July 31, 2016

Re: First Request for Additional Information (RAI)
Pasco County – Solid Waste
Facility Name: Enterprise Road Class III Recycling and Disposal
Facility Site ID: 87895
DEP Application Nos.: 177982-023-SC/T3 and 177982-024-SO/T3

REVISED
FIGURE
S-1

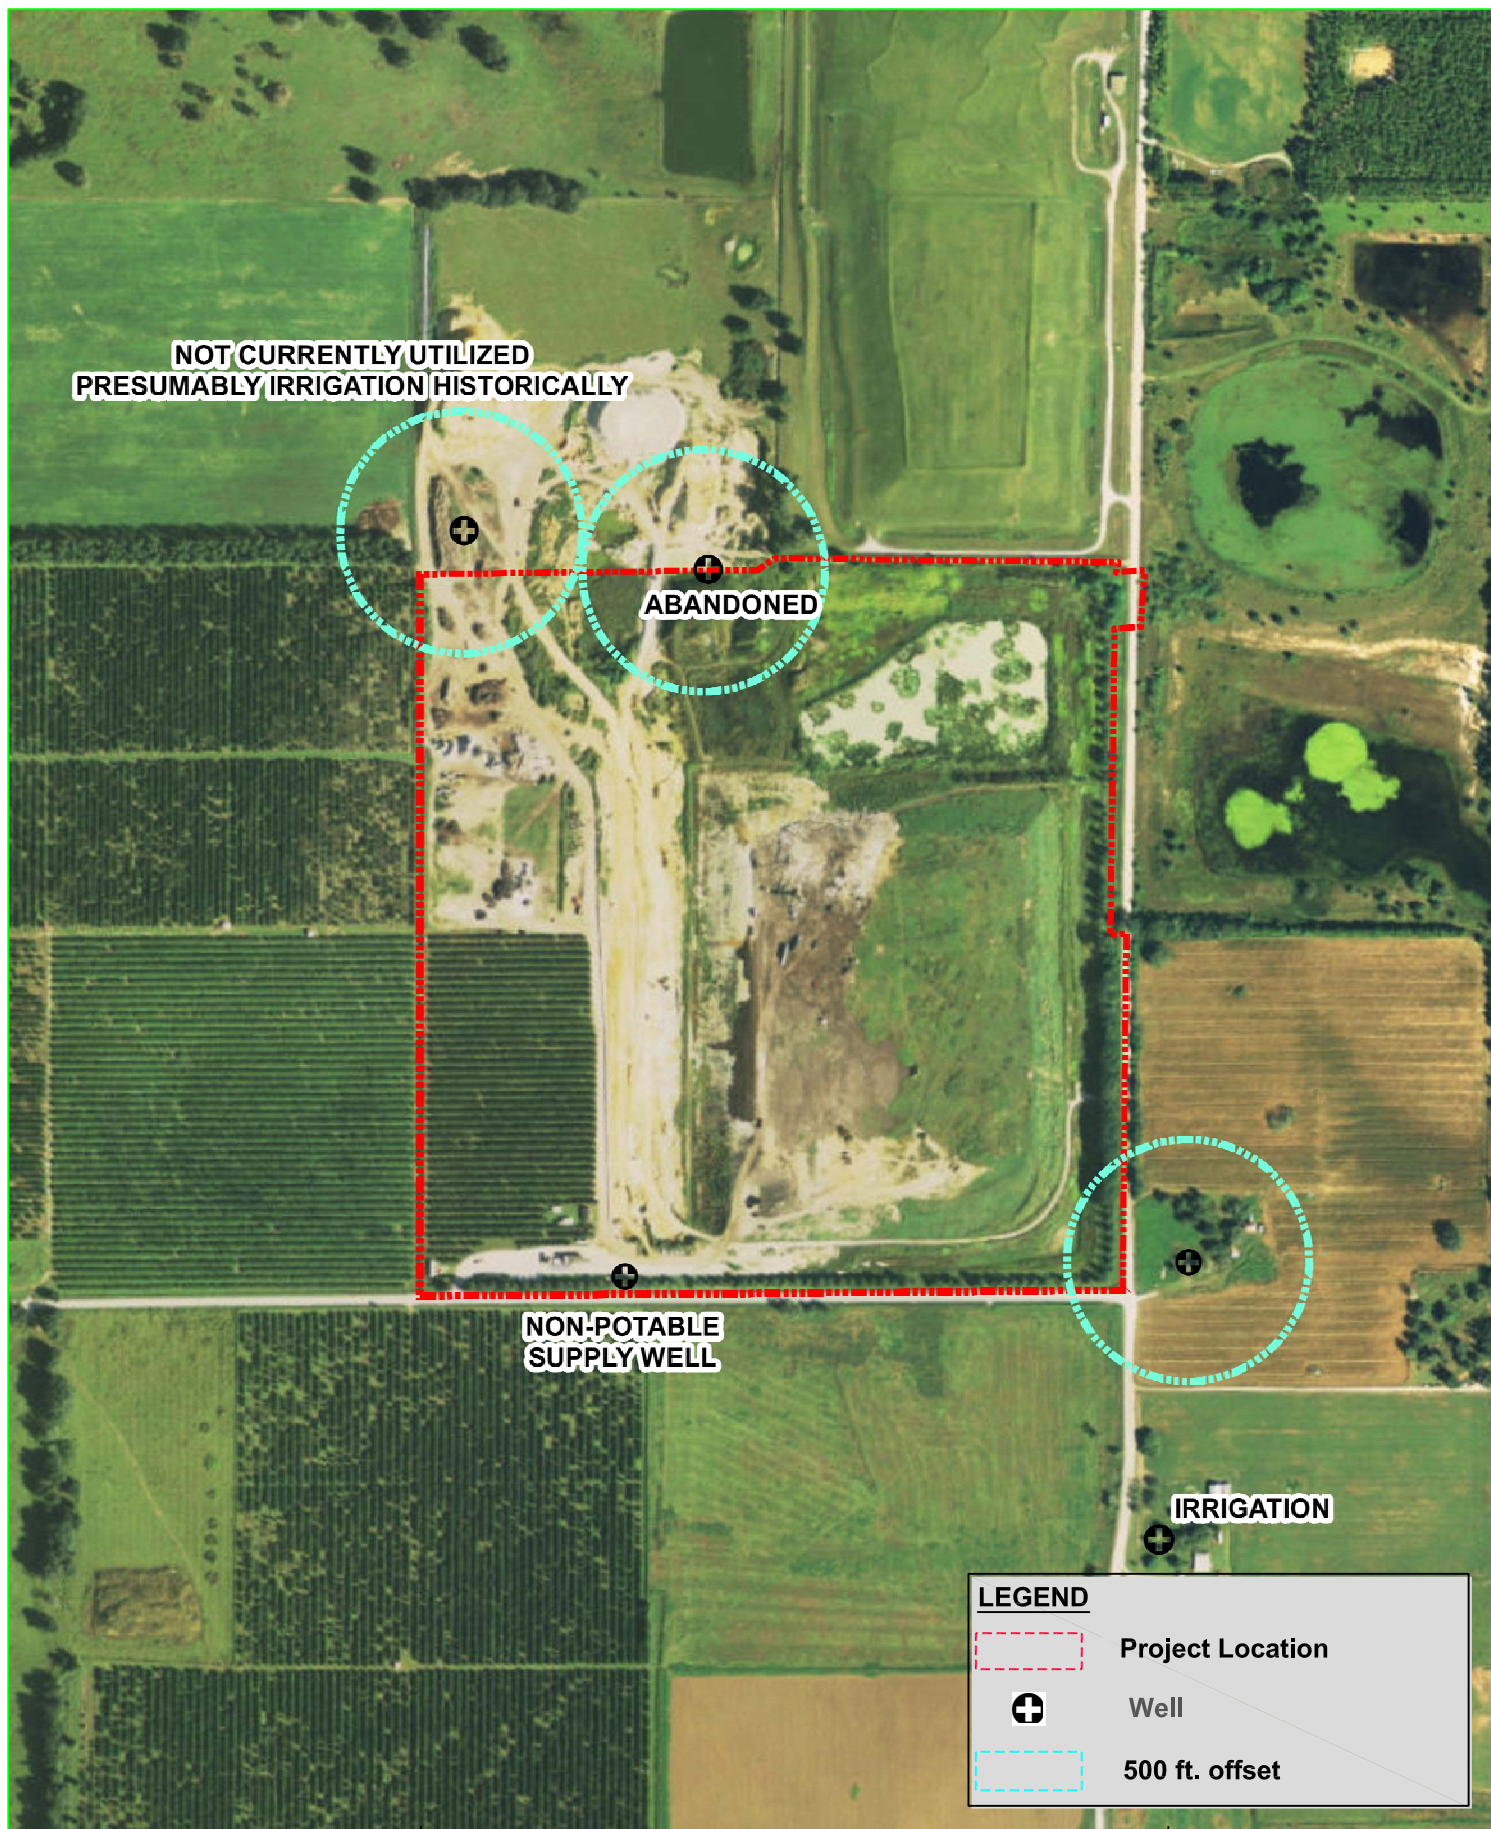
Comment 29: Figure 5: Please verify the presence of an off-site potable wells west and southeast of the site, as depicted on Figure S-1 provided with the engineering report for the current facility permits and revise this figure, as applicable.

RESPONSE 29: Potable Well Location Map has been revised and is located in Section 3 Appendix 3-C. The well located north of future cell 13 has been abandoned. The well northwest of future phase 12 has been added to the map, however, this well is currently not used and was presumably used for irrigation historically. The well east of the southeast corner of Cell 2 has been added to the map. The well to the southeast of the southeast corner of the property in Figure S-1 is permitted as "irrigation" by the SWFWMD. Additionally, the two wells identified as "potable wells" in Figure 5 of the 2015 permit modification are also permitted as "irrigation" by the SWFWMD. The Potable Well Location Map (Figure 5) has been revised and is located in Section 3, Appendix 3-C.

Revised Potable Water Wells
Enterprise Road Class III Recycling and
Disposal Facility Permit Modification
Dade City, Pasco County, Florida

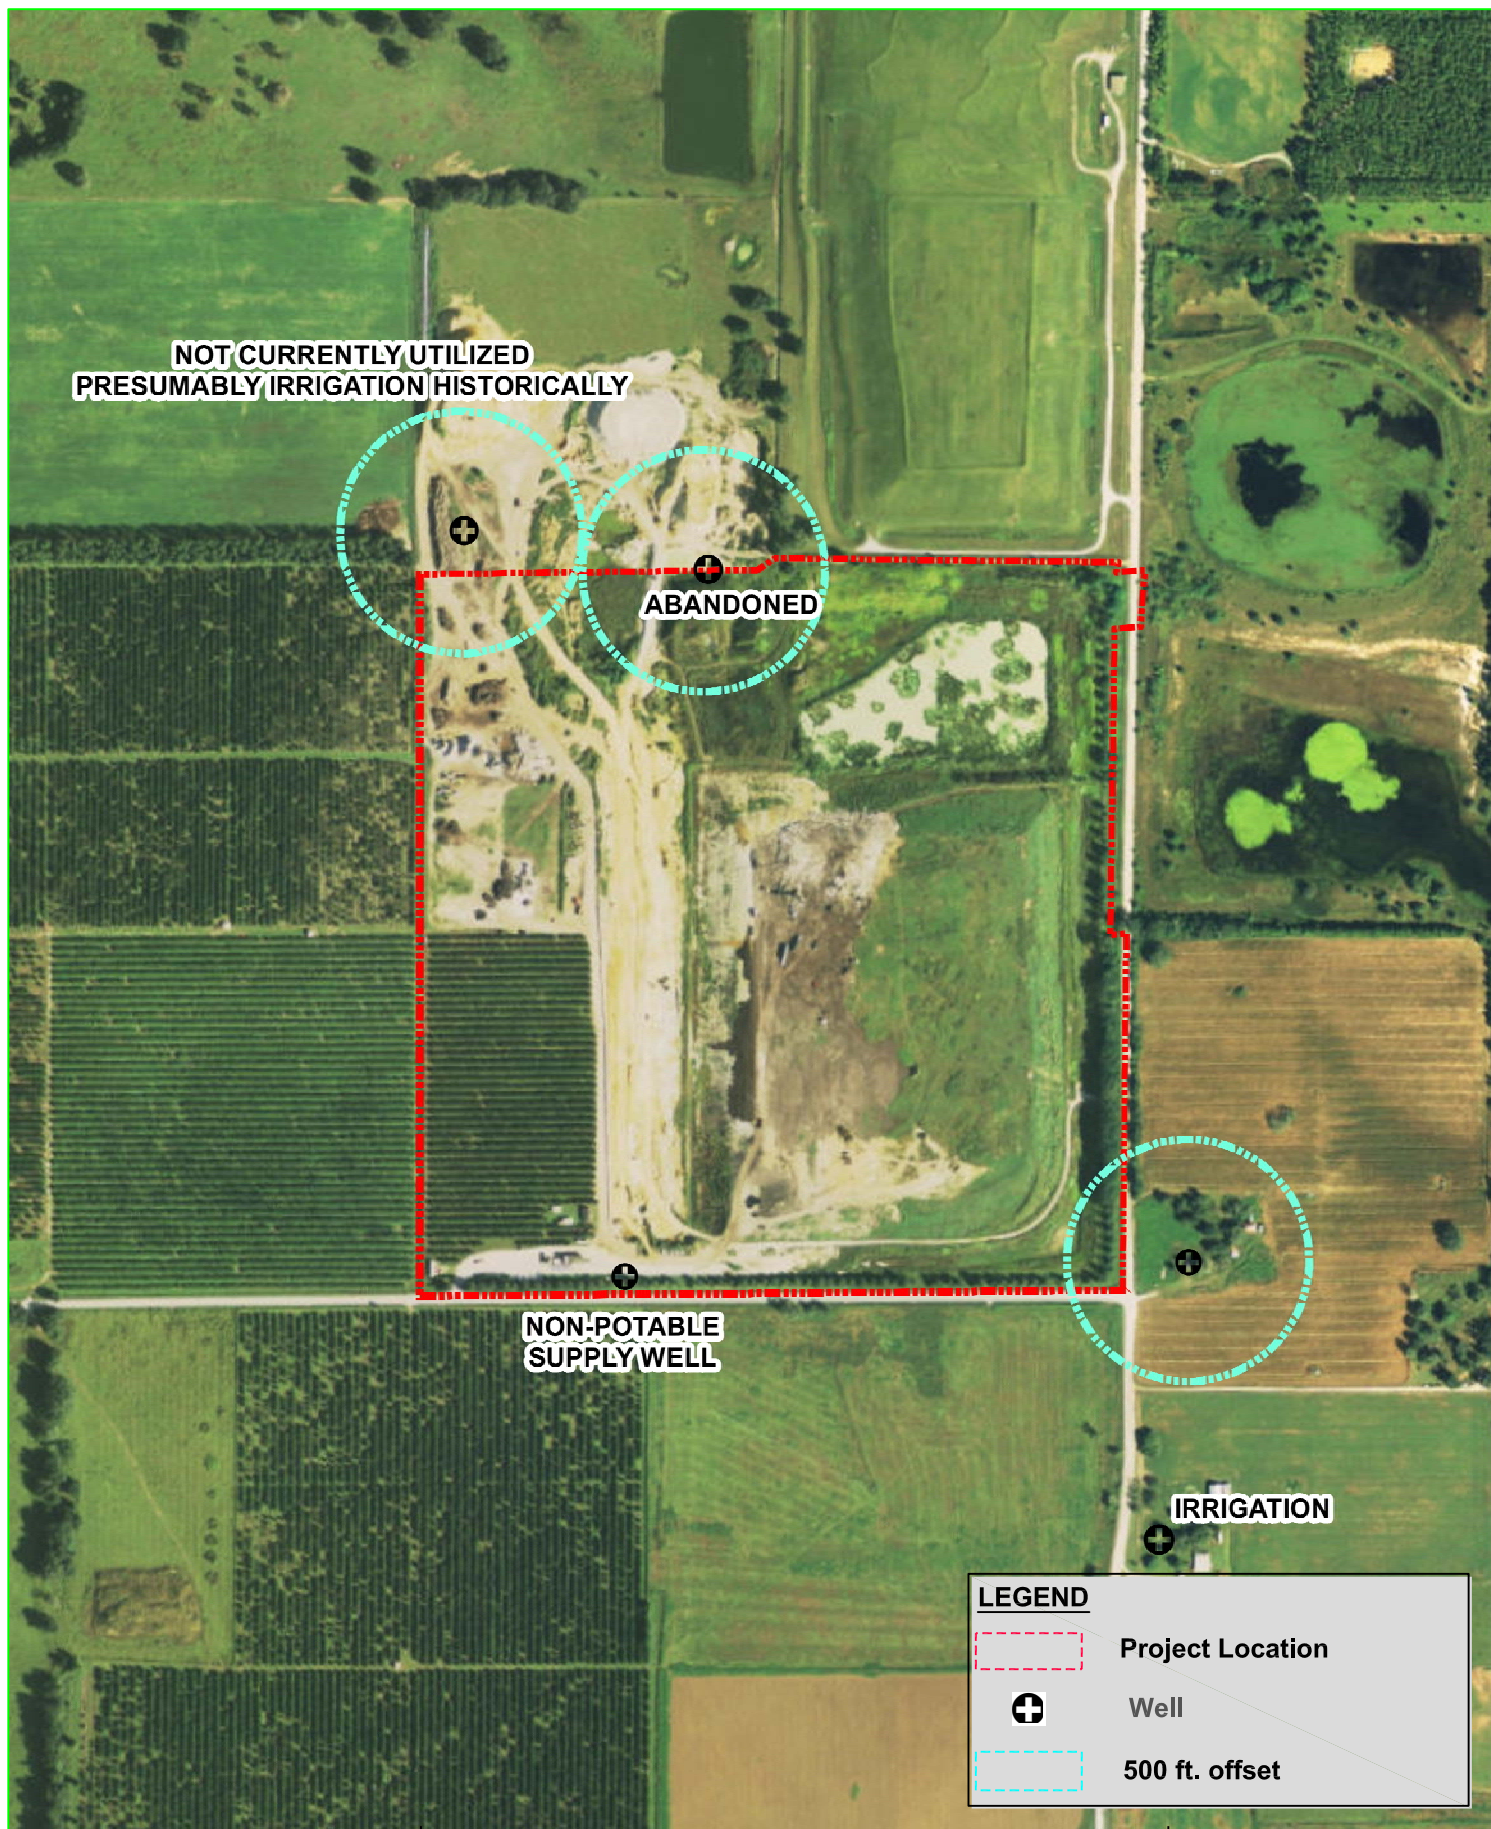
Comment 33: §6.2.4: ¶2 of this section refers to the potable well survey provided in Attachment 3. The figure provided in Attachment 3 (titled "Potable Well Location Map") was compared to the locations depicted on Figure S-1 (titled "Potable Water Wells") presented in Attachment H-1 of the Engineering Report submitted by Kelner Engineering dated march 2013 in support of the permit renewal application. It is understood that the private well located north of conceptual Cell 13 has been abandoned; however the two other wells on Figure S-1 (in the citrus grove west of conceptual Cell 11 and off-site to the southeast of Cell 2) have been omitted. Additionally, the on-site supply well located southwest of Cell 7 is not presented on the figure in Attachment 3. Please review the omitted well locations and submit revisions to Attachment 3 as appropriate.

PROJECT NO.:	02000-144-14
SCALE:	AS SHOWN
DATE:	MARCH 2016
DRAWING:	CO.04

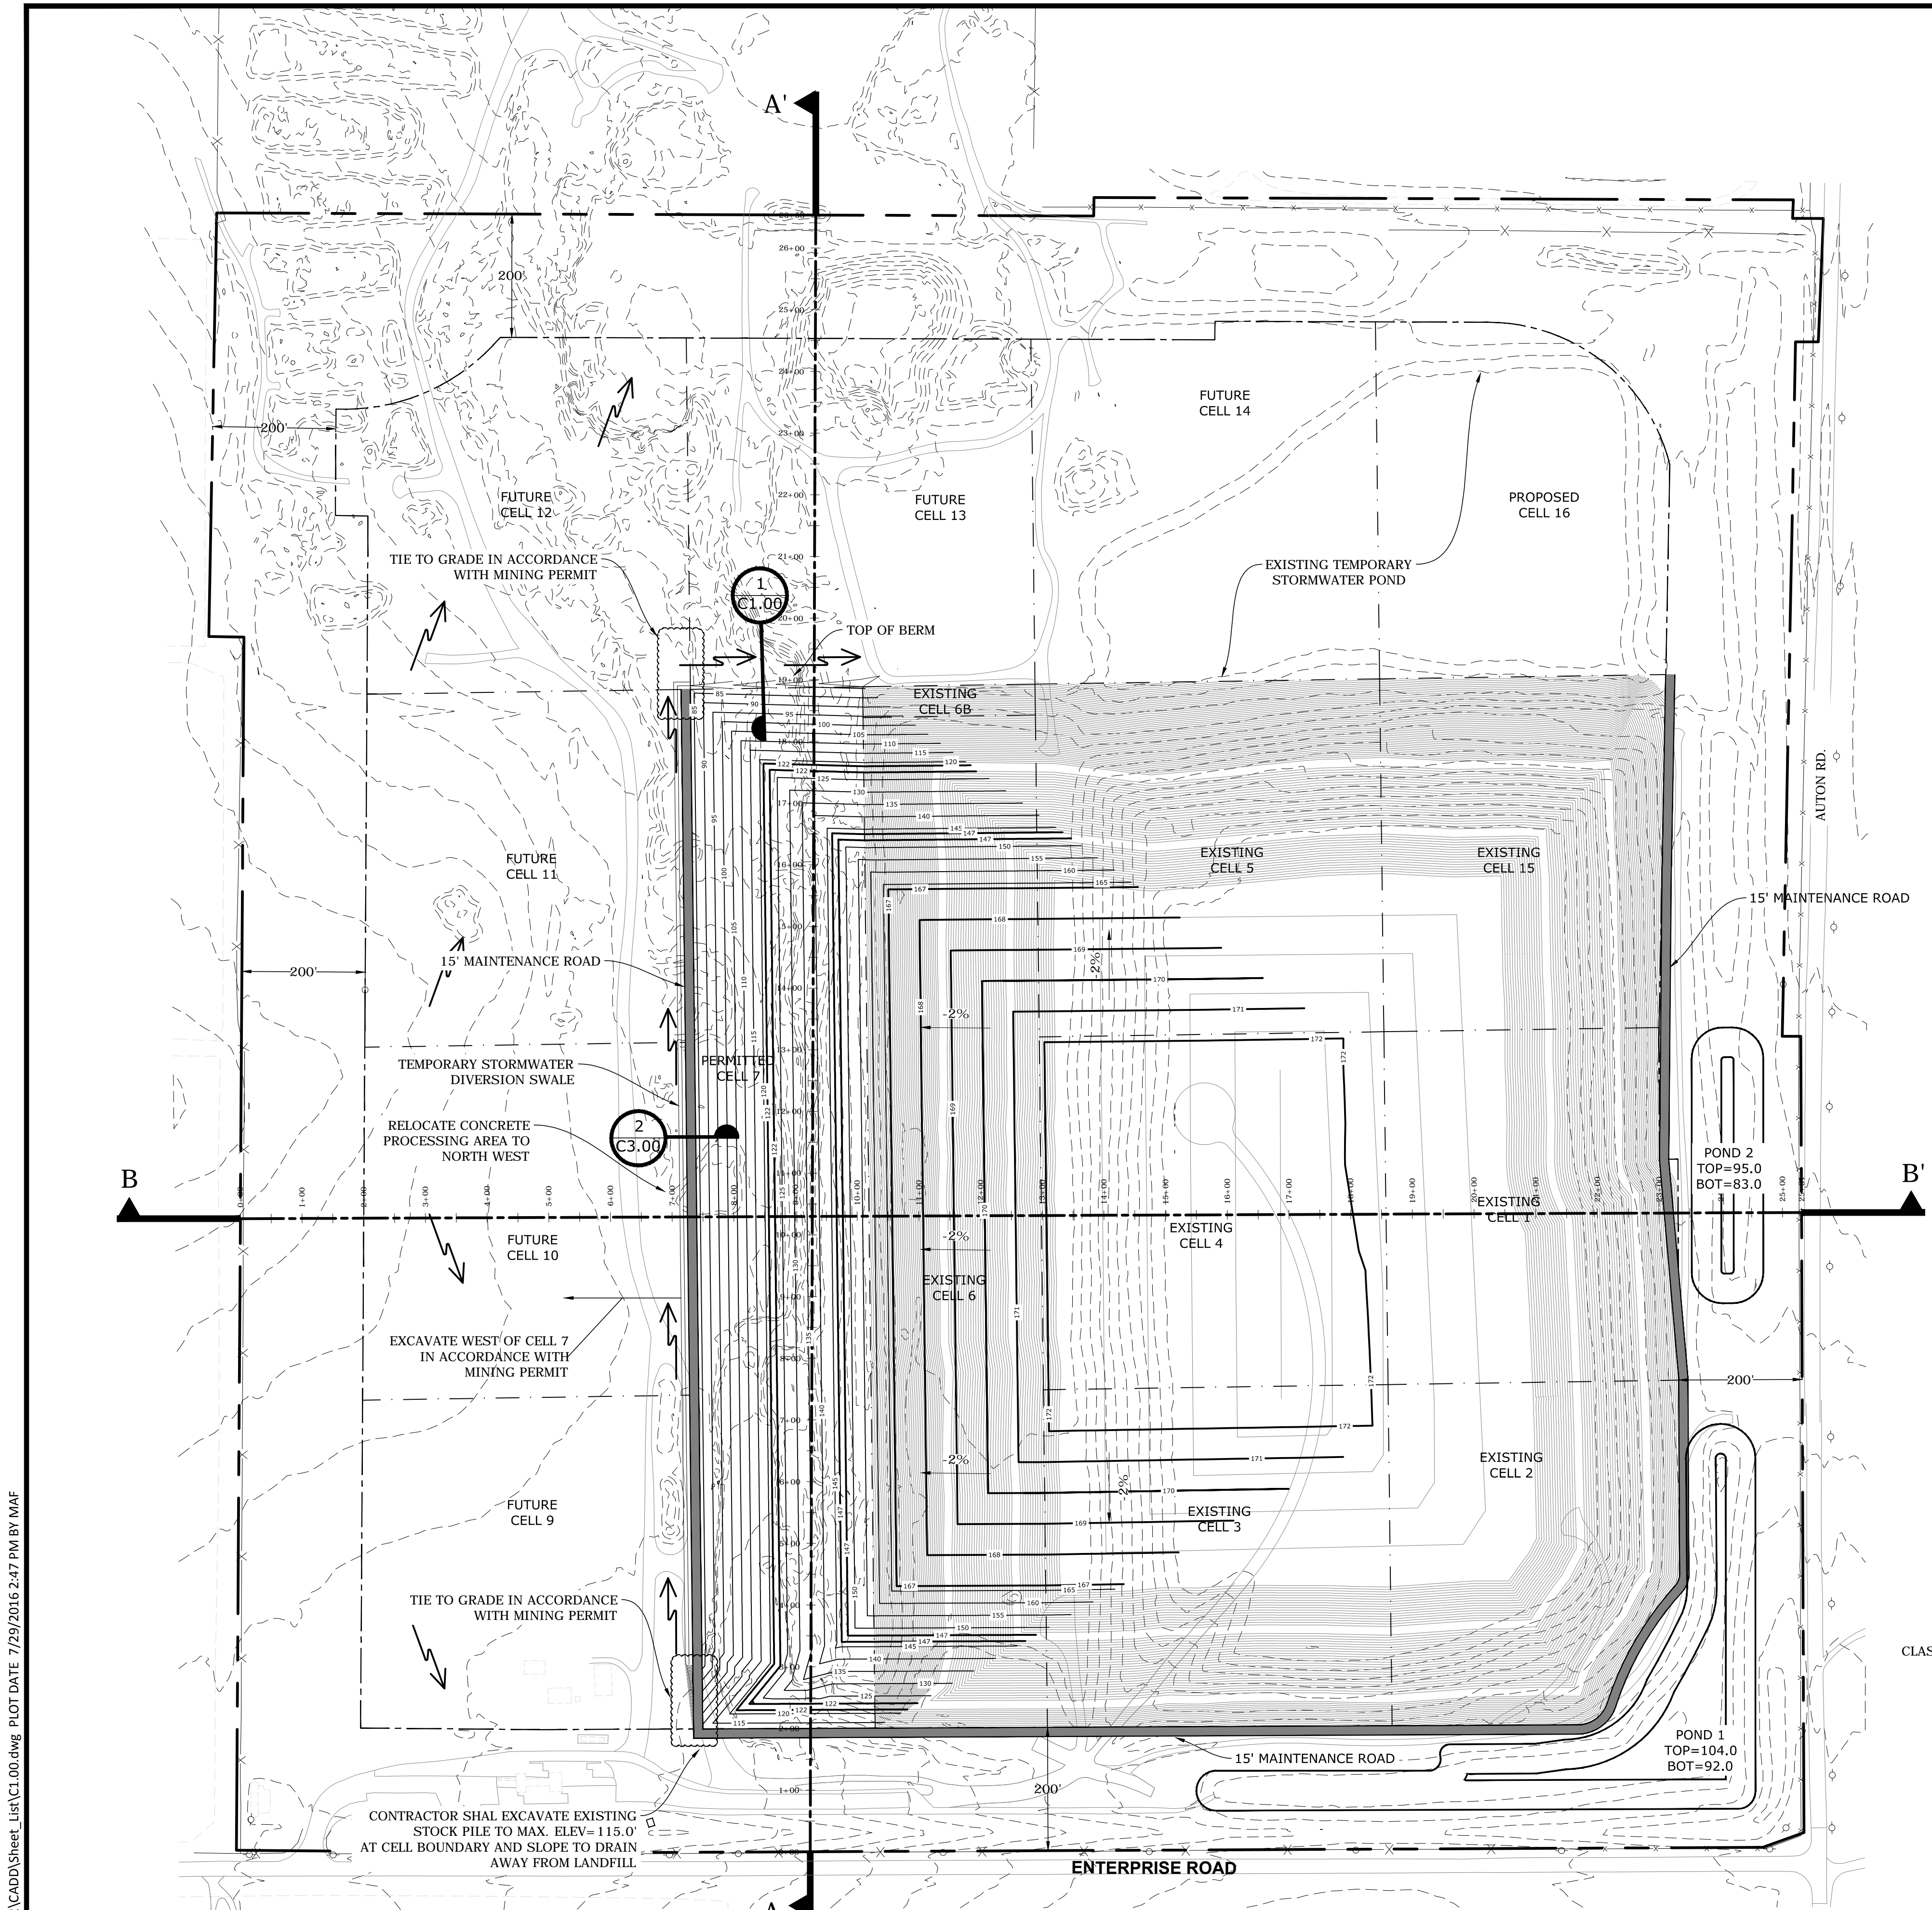
Comment 23: Drawing C0.04: Please revise this drawing to also include the cell floor grading for Cell 7.

RESPONSE 23: Drawing C0.04 has been revised to include the cell floor grading for Cell 7 as presented in the 2013 Kelner Engineering Permit Application.
